Metropolitan Planning Commission

**Part B Subdivisions & PUD
UDO Request**

Staff Reports

April 24, 2008

Site Plan

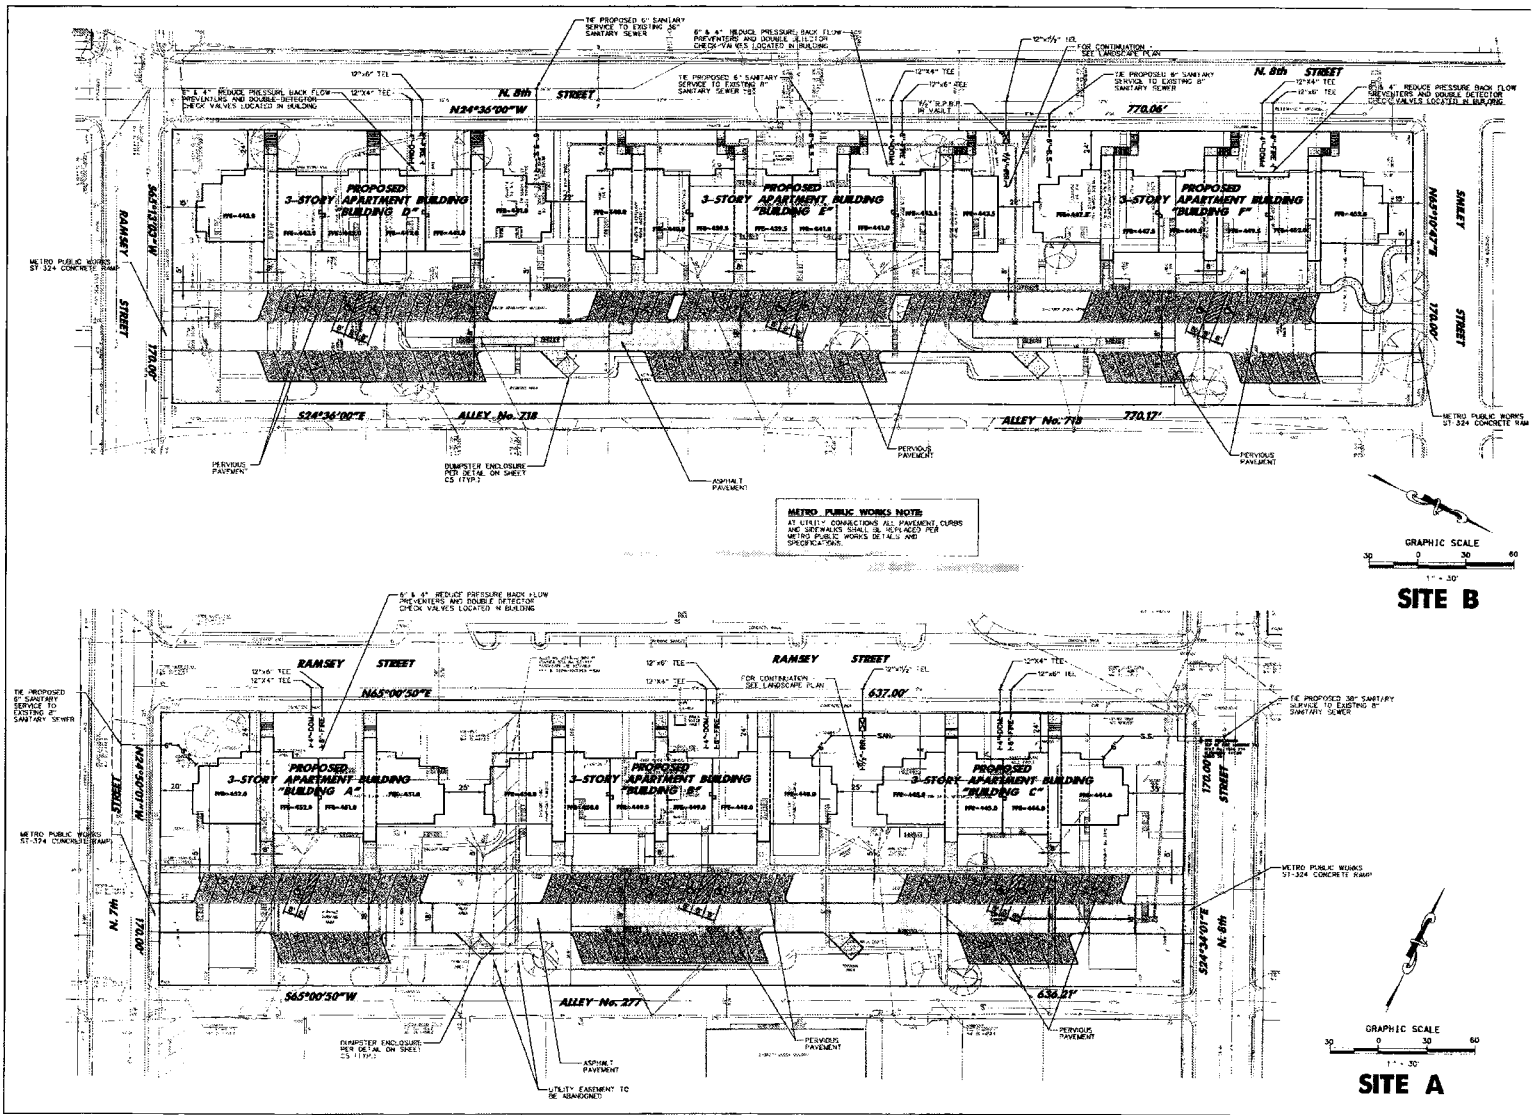
1. The Stormwater BMP Operation and Maintenance Agreement is required to be recorded prior to final plan approval. The O & M Agreement is comprised of three elements: (1) The Inspection and Maintenance Agreement signed by the developer or owner, (2) the Long Term Maintenance Plan and, (3) a drawing of easements on a plat or a system location map to help MWS locate the BMPs as needed. Please refer to Appendix C of the Stormwater Management Manual Volume 1 for further instructions.

2. Drainage easements will be required to be recorded, either by plat or by separate instrument, for the two water quality units. If this property will not be platted through the Metropolitan Planning Commission, then you must submit a completed Dedication of Easement Form. The grading plan cannot be approved until the easement is reviewed and approved by Ron Sweeny's office.

7. The minimum length of a construction exit is 100 feet. Please revise the detail.
8. Change note 3 on sheet C4 to state that stabilization methods will be applied within 14 days of final grading.

9. Please show the size of the pipes that both systems propose to tie into. Indicate if the existing storm system carries storm only or if it is a combination storm and sanitary sewer line. If it is a CSO line, please provide written approval from Metro Water and Sewer.

10. Please provide a drainage area map showing existing conditions and flow patterns and the outfall point(s) being analyzed.
11. Please provide a drainage area map showing proposed conditions and flow patterns and the outfall point(s) being analyzed.
12. Please provide pre- and post-developed peak flow rates for the 2-year, 5-year, 10-year, 25-year, 50-year, and 100-year storm events using the SCS Method. Increases in peak flow rates are not allowed, especially in the CSO.
13. No credit is given towards stormwater quantity for the use of porous concrete. Please re-evaluate the stormwater quantity analysis (see items 10-12).

2. A revised plan addressing all Stormwater comments listed above must be submitted to the Stormwater Division for approval.
3. The requirements of the Metro Fire Marshal's Office for emergency vehicle access and adequate water supply for fire protection must be met prior to the issuance of any building permits.
